International Isotopes Inc.

Subject: Submittal of Responses to Requests for Additional Information (RAI)
TAC L32739

The following document is provided as a response to the US Nuclear Regulatory Commission RAIs pertaining to the International Isotopes Fluorine Products Inc. December 30, 2009 application to license a depleted uranium hexafluoride de-conversion and fluorine extraction process facility.

Quality Assurance (Management Measures)

Figure 11-2 Plant Operation Organization

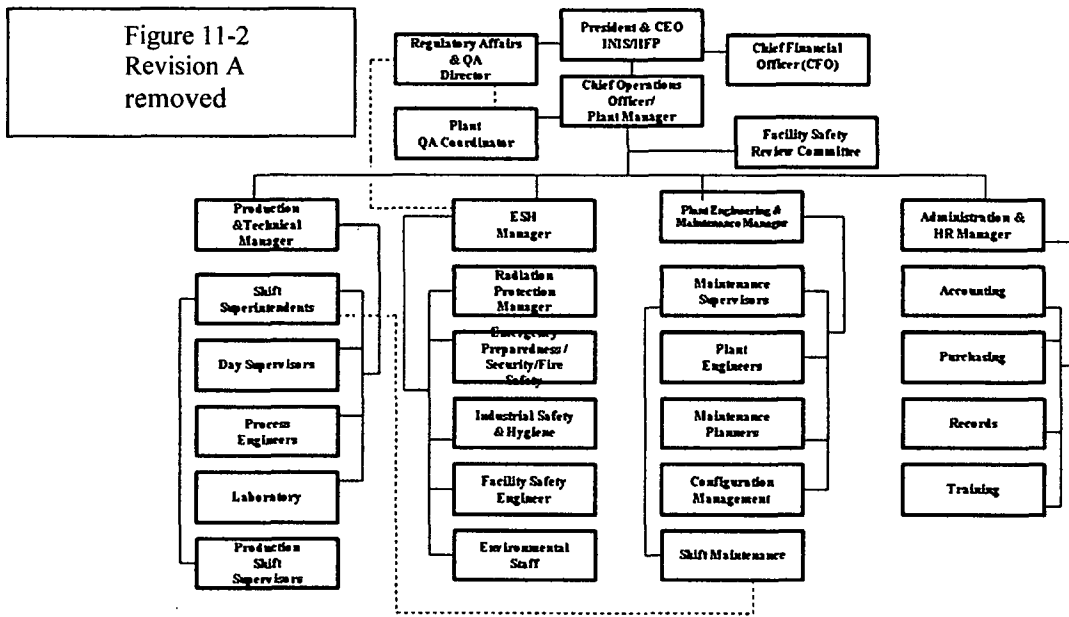
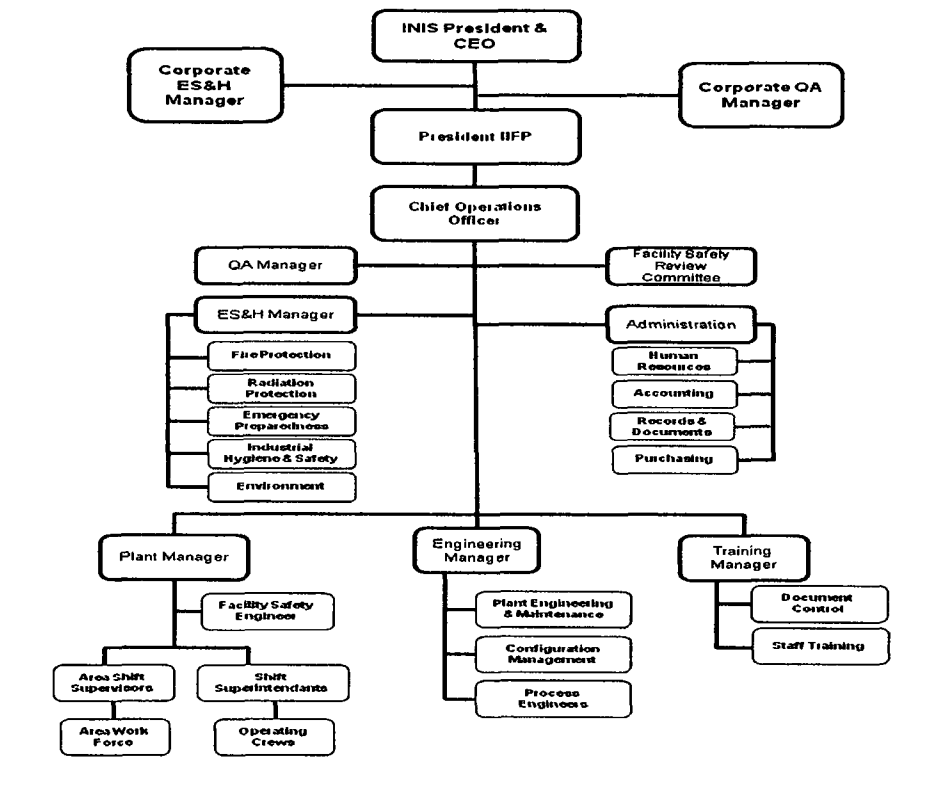
Figure 11-2 "IIFP Plant Organization during Operations of the FEP/DUP Facility" will be removed and replaced with Figure 11-2 "Plant Operation Organization" depicting the organizational structure of the Facility, in response to RAI OA-7A.

License Documentation Impact: Remove Figure 11-2 and title and replace with revised Figure 11-2 "Plant Operations Organization" in the Chapter 11 of IIFP License Application, Revision A, (also in response to RAI OA-7) the revised Figure and will appear as follows:
